Randolph Pump Station Improvements Project
Solicitation Number: CO-00459
Job No.: 20-8611

ADDENDUM NO. 6
January 18, 2023

10. Sheet S-10 Sodium Hypochlorite Generation Building Section II

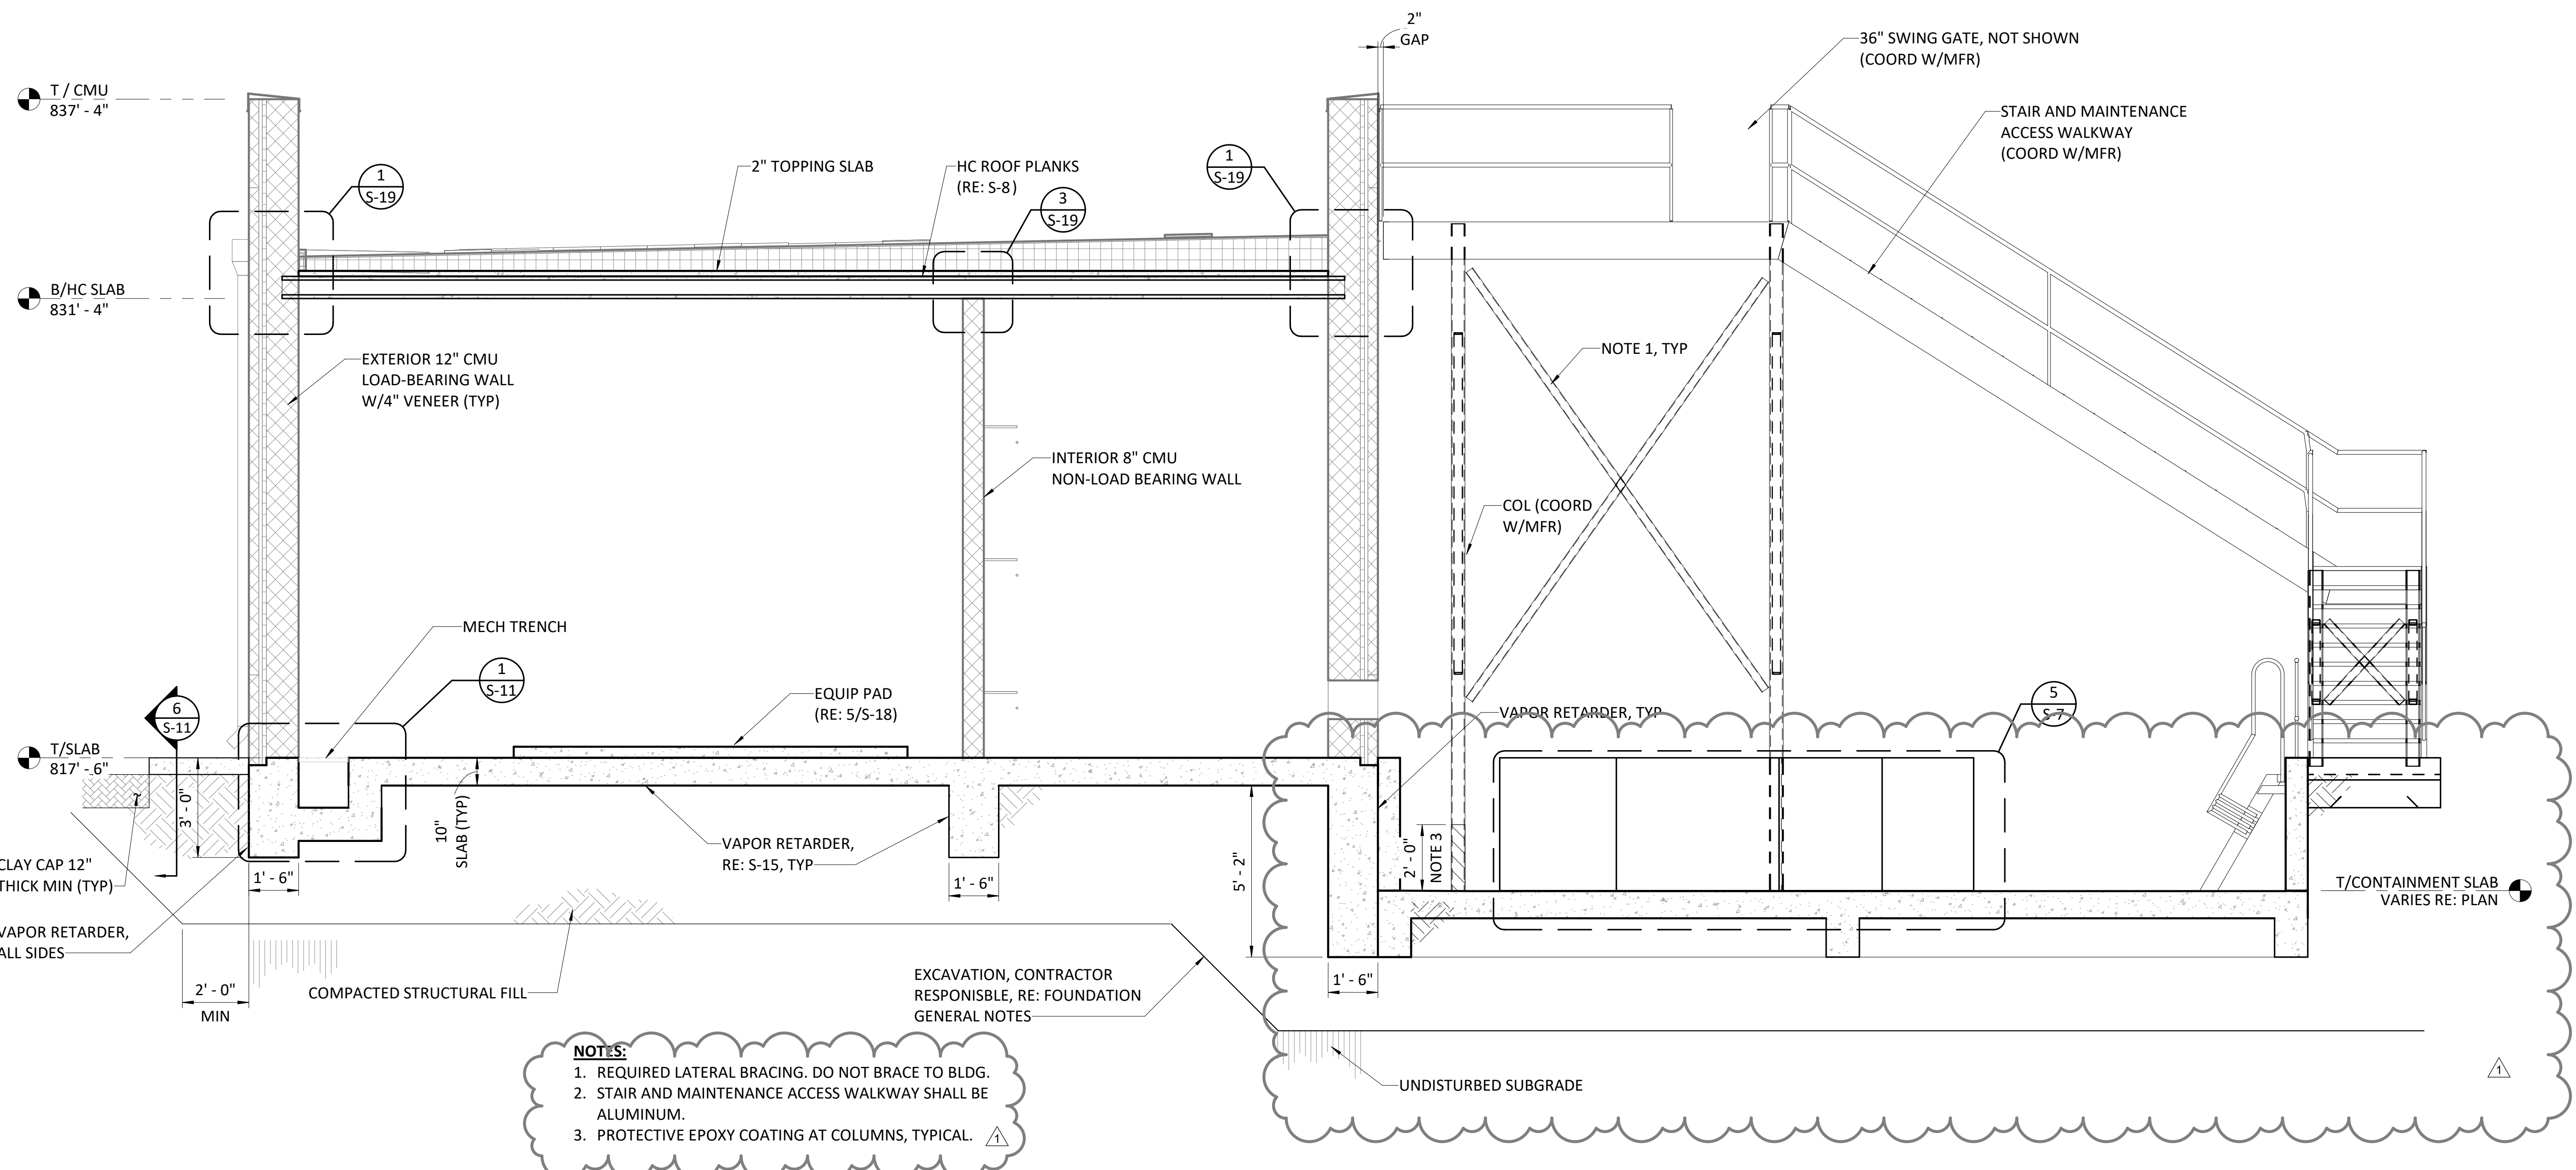
- 39. Question: On sheet S-7 call for the stairs and maintenance walkway to be alum and on sheet S-10 note 2 calls for them to be stainless steel. Please clarify what materials the stairs and maintenance walkway should be.**

Response: Sheet S-10 updated to note the stairs and maintenance walkway are to be aluminum. See Item No. 10 in CHANGES TO THE PLANS section of this addendum.

11. Sheet S-12 Fluoride Building and Transformer Pad Foundation Plans and Sections

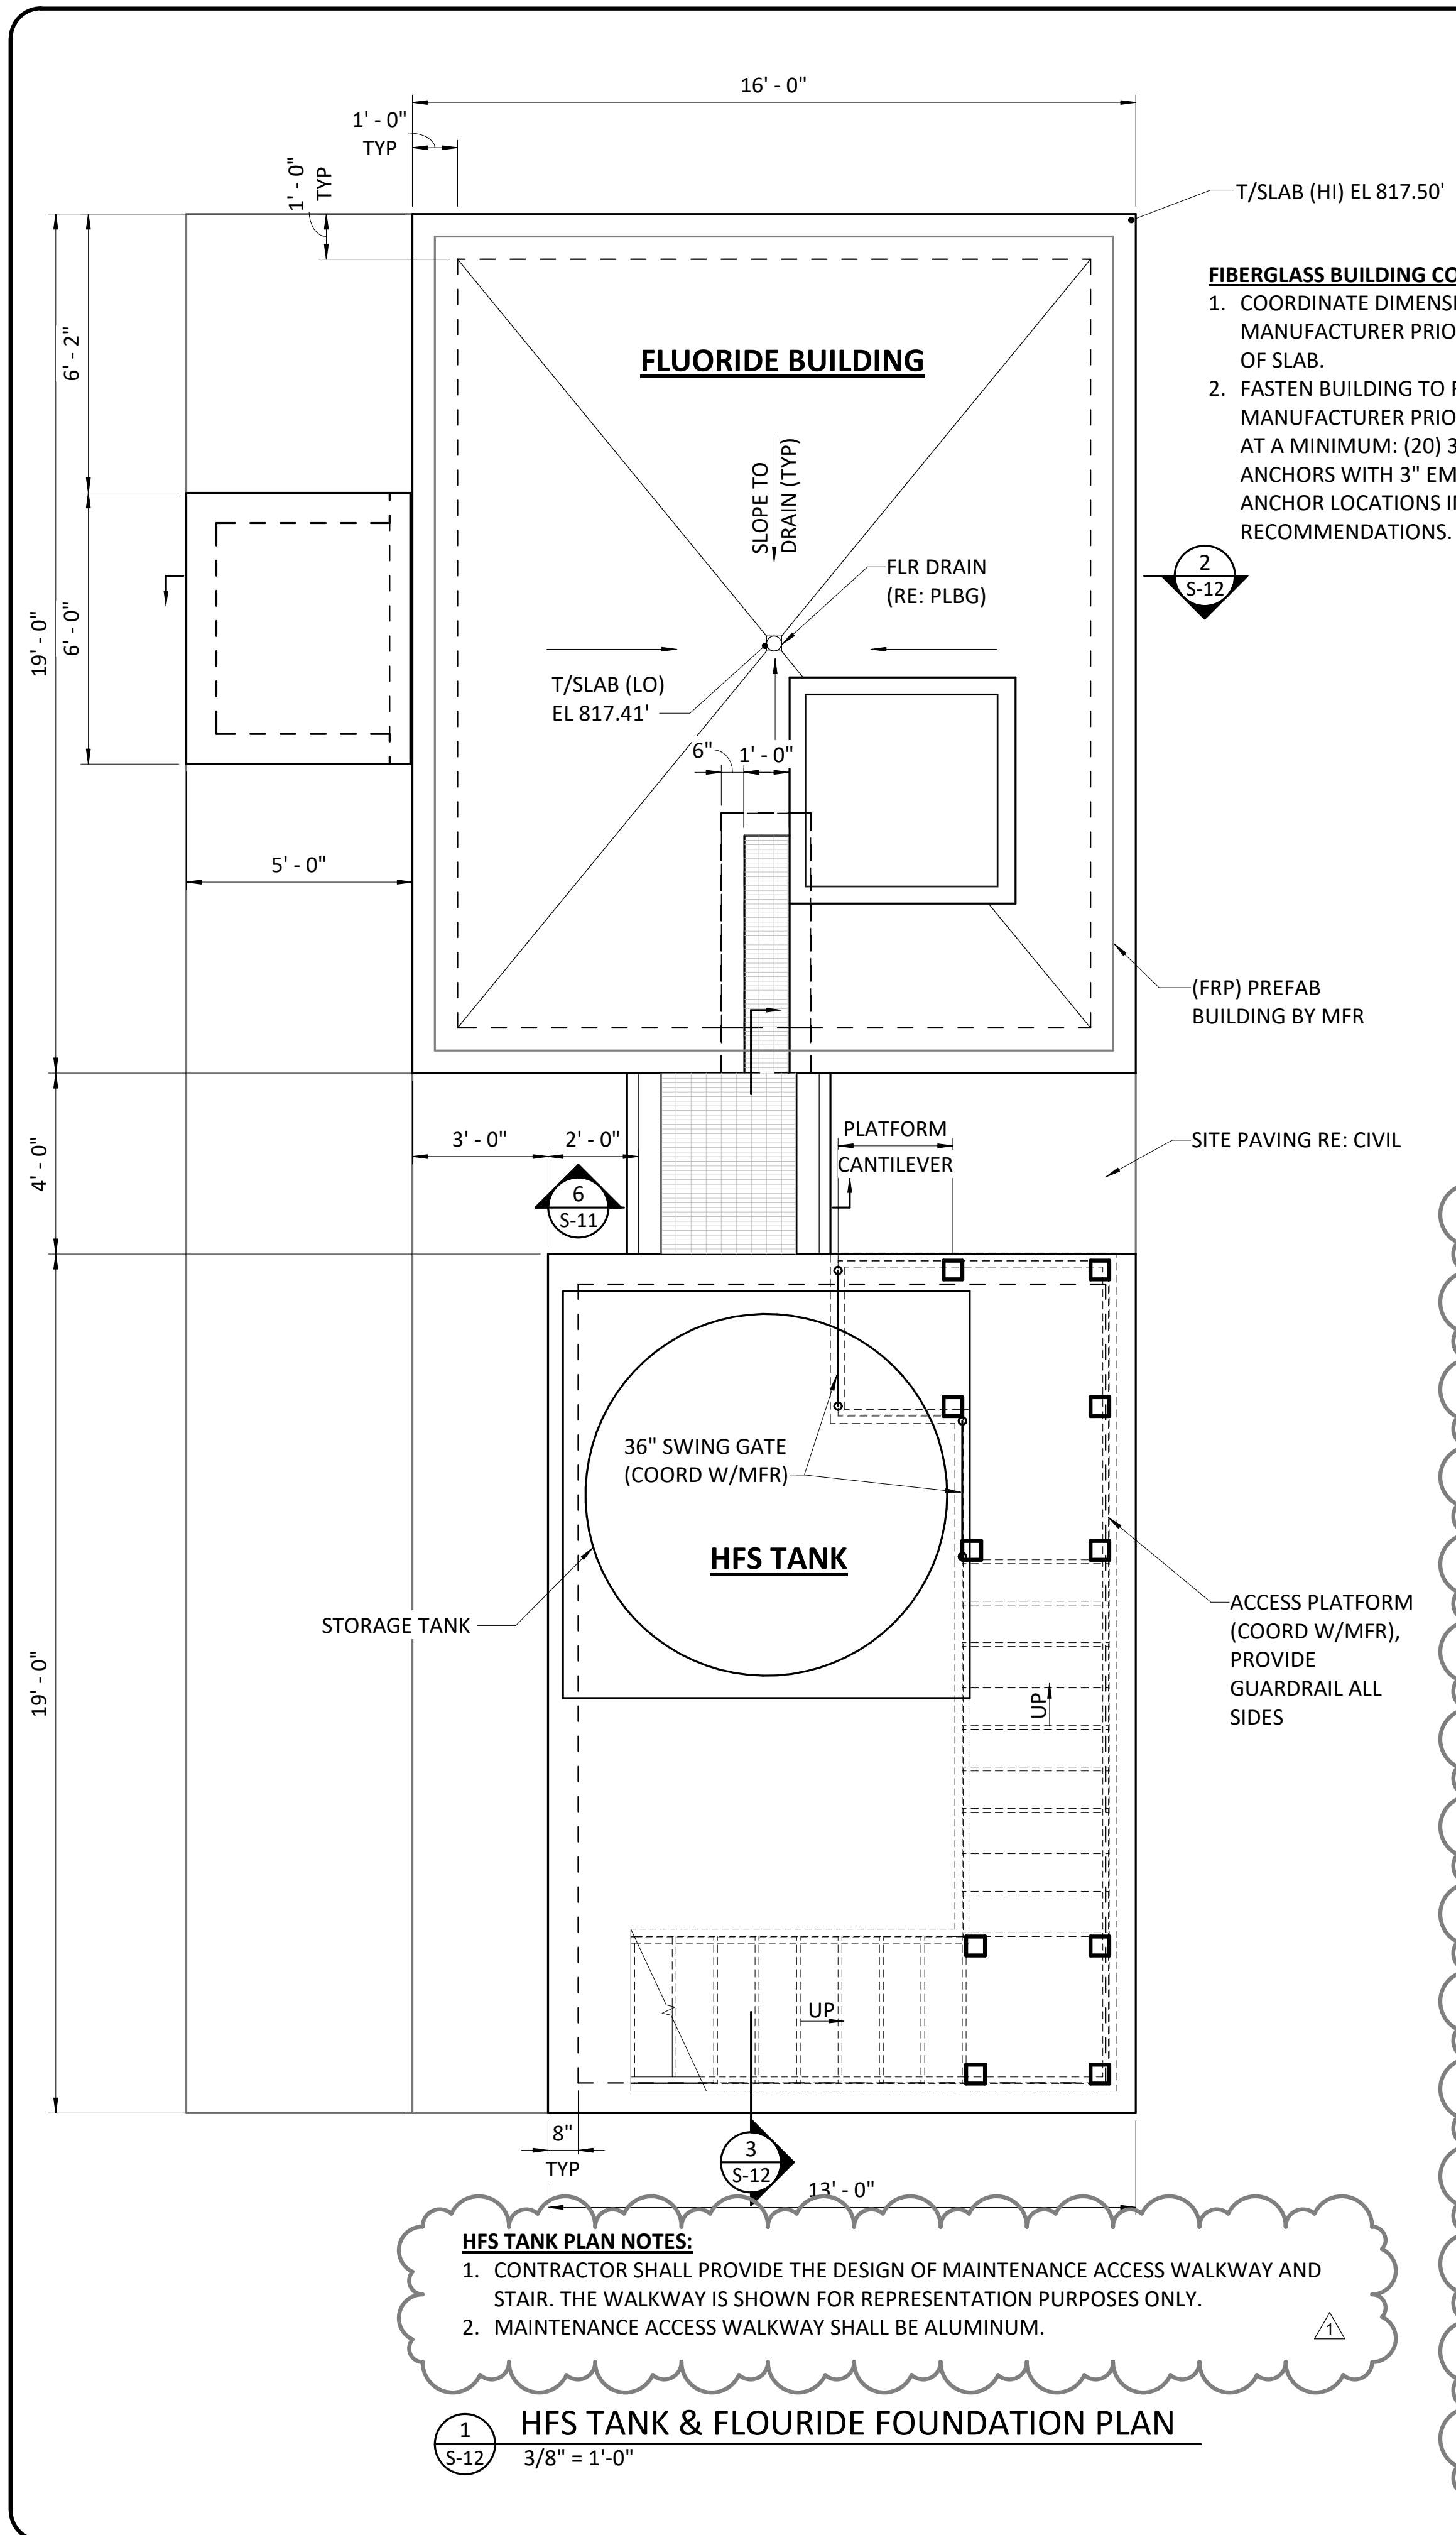
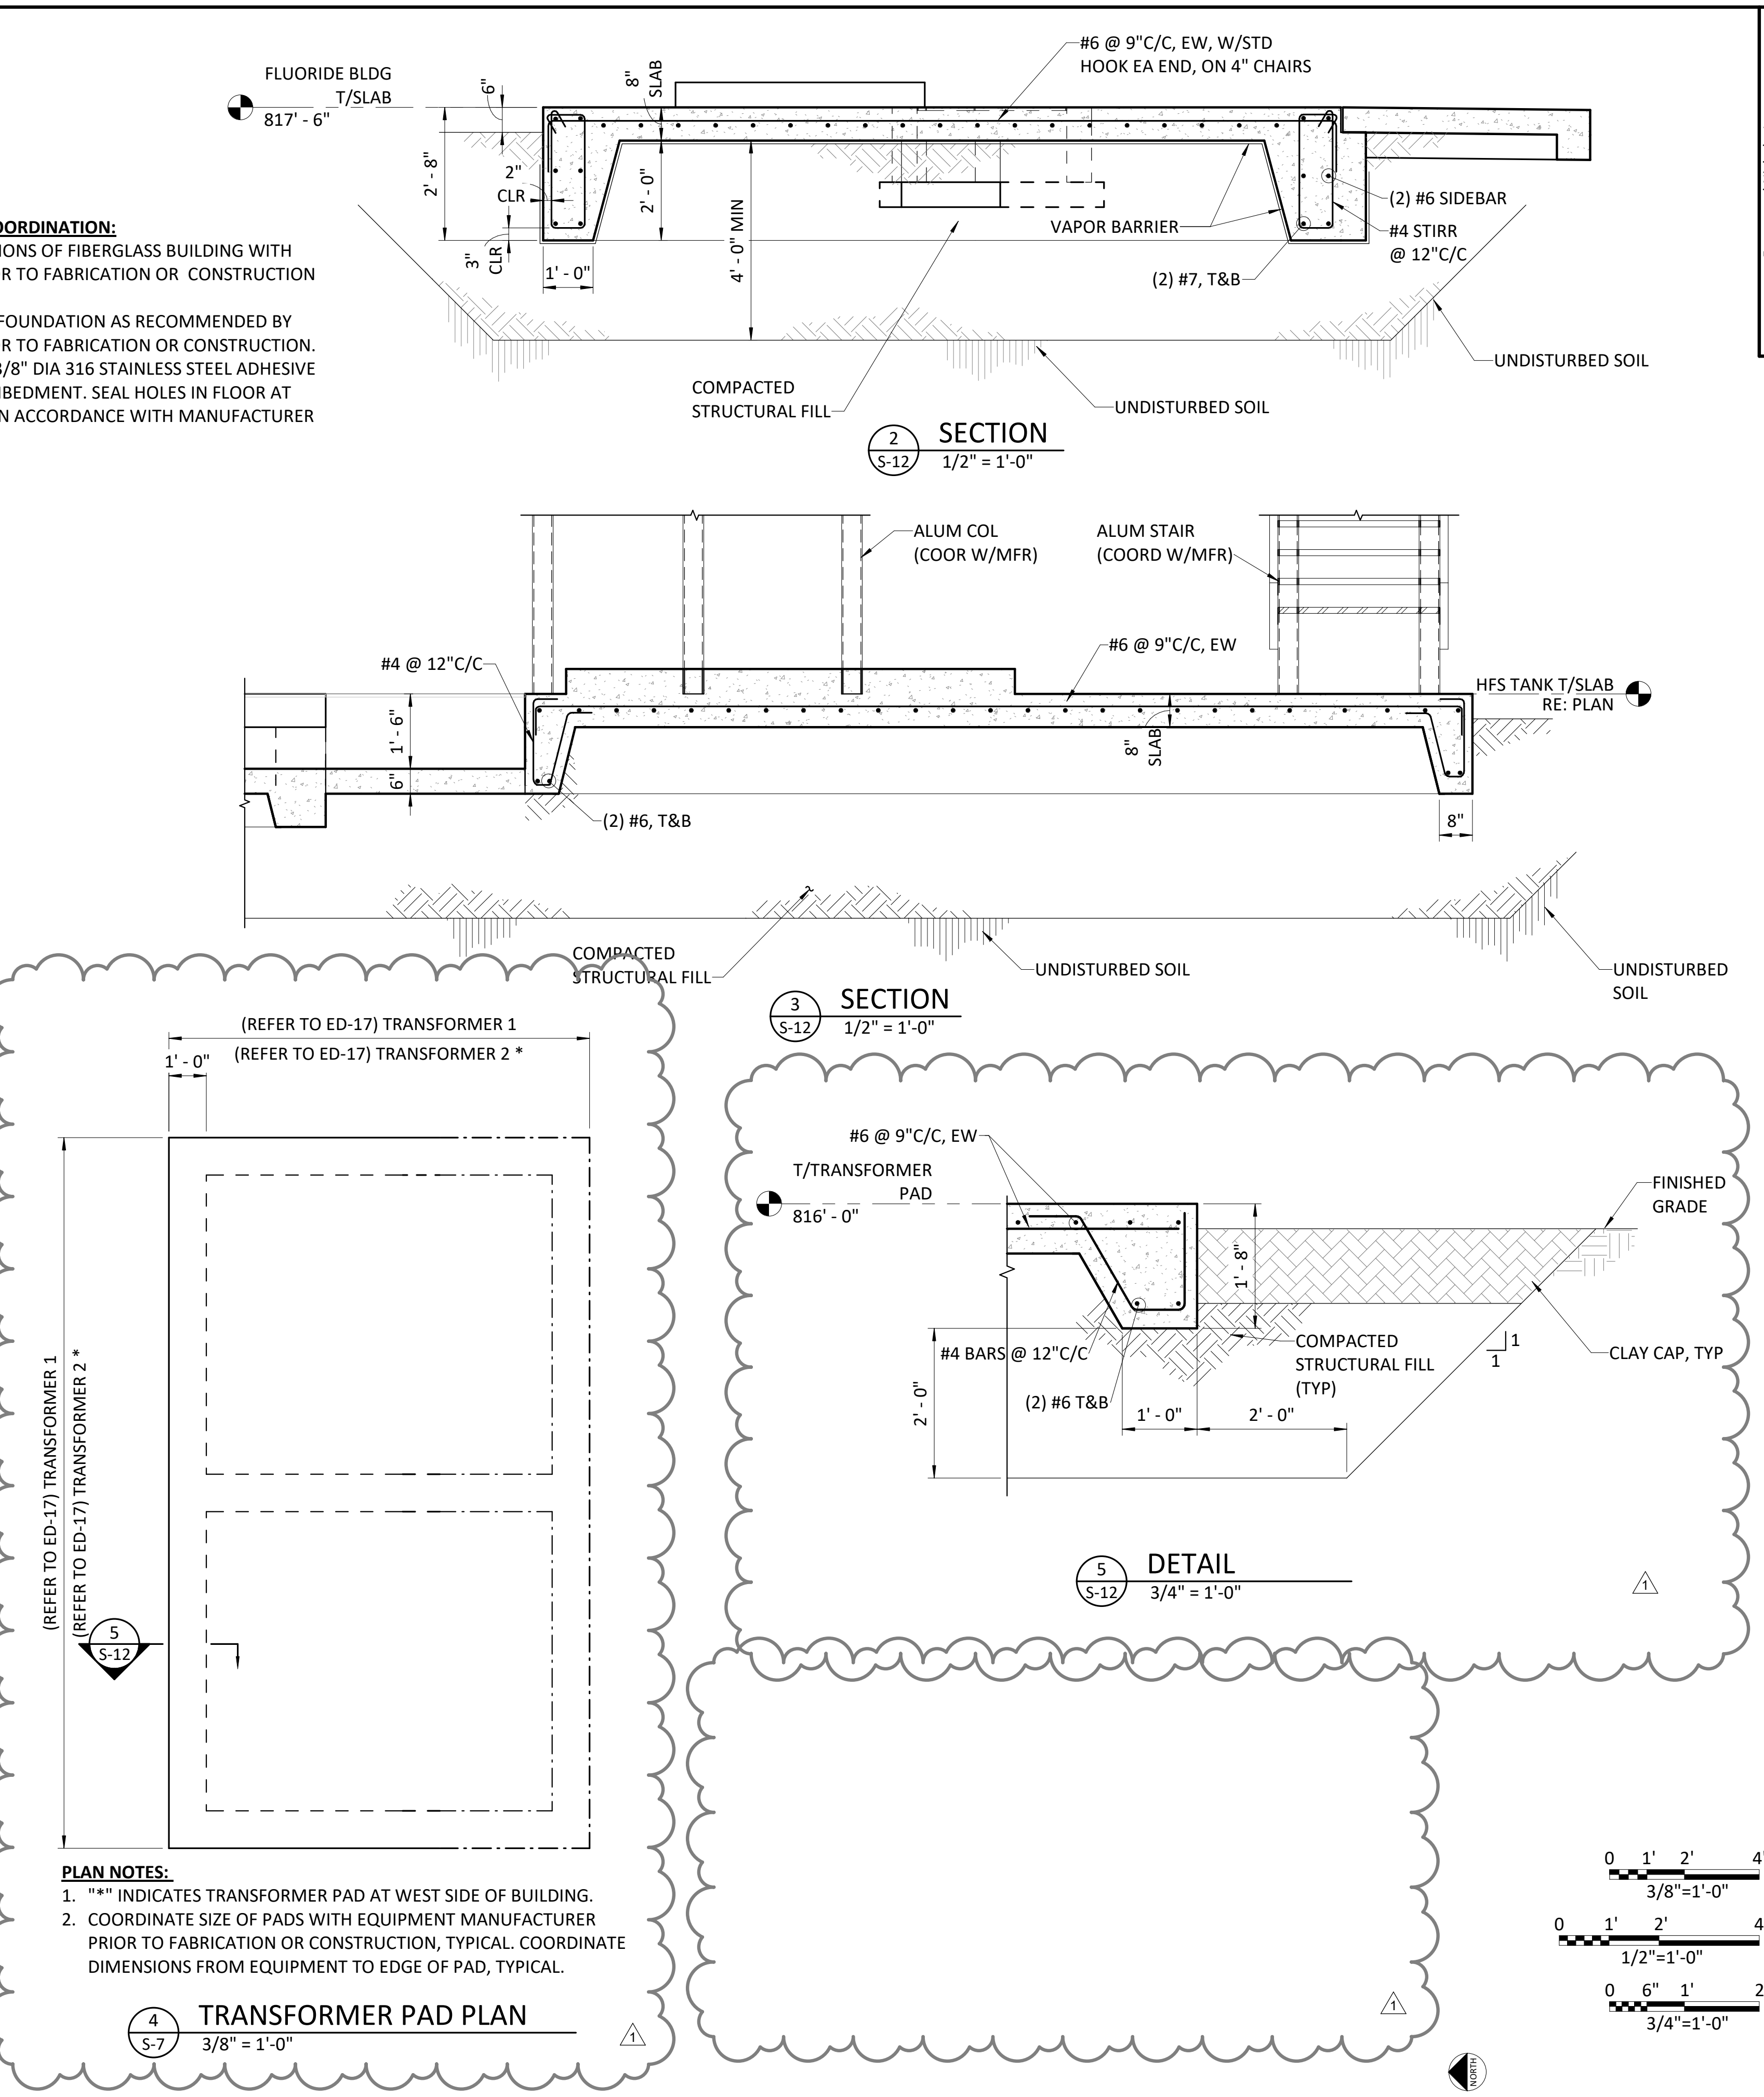
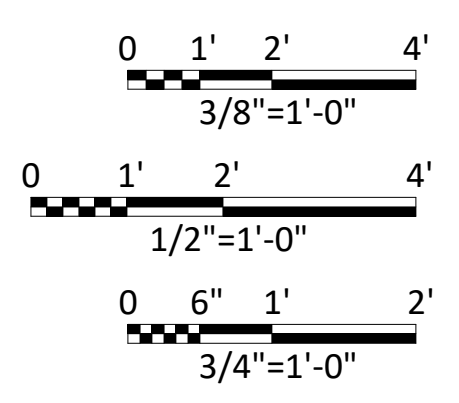
- 1. Question: Contract Drawing S-12 Detail 4 which clearly referring to Transformer No.1. For the purpose of this project we're only going to do The Phase 1 or Phase 1 & Phase 2. Please advise.**

- 4. Question: Sheet S-6 and S-12 show Transformer Pads that depict a Phase 1 and 2 size. The plan view shows a 2" x 8" perimeter curb. Is the curb between Phase 1 and 2 to be removed and patched back? Please advise.**

Response: Detail 4/S-12 has been updated to remove references to Phase 1 and Phase 2. See Item No. 11 in the CHANGES TO THE PLANS section of this addendum for the update to Sheet S-12. Sheet S-12 contains the structural details for the OSG Building and Electrical Building transformer pads. Sheet EZ-8 contains the standard details for the CPS Energy transformer pad. See Item No. 25 in the CHANGES TO THE PLANS section of this addendum for the update to Sheet EZ-8 and Item No. 1 in the CHANGES TO THE PLANS section of this addendum for the update to the CPS Energy transformer pad location.

Response: Phase 1 and Phase 2 references have been removed. See Item No. 8 in the CHANGES TO THE PLANS section of this addendum for the update to Sheet S-6, and Item No. 11 in the CHANGES TO THE PLANS section of this addendum for the update to Sheet S-12.
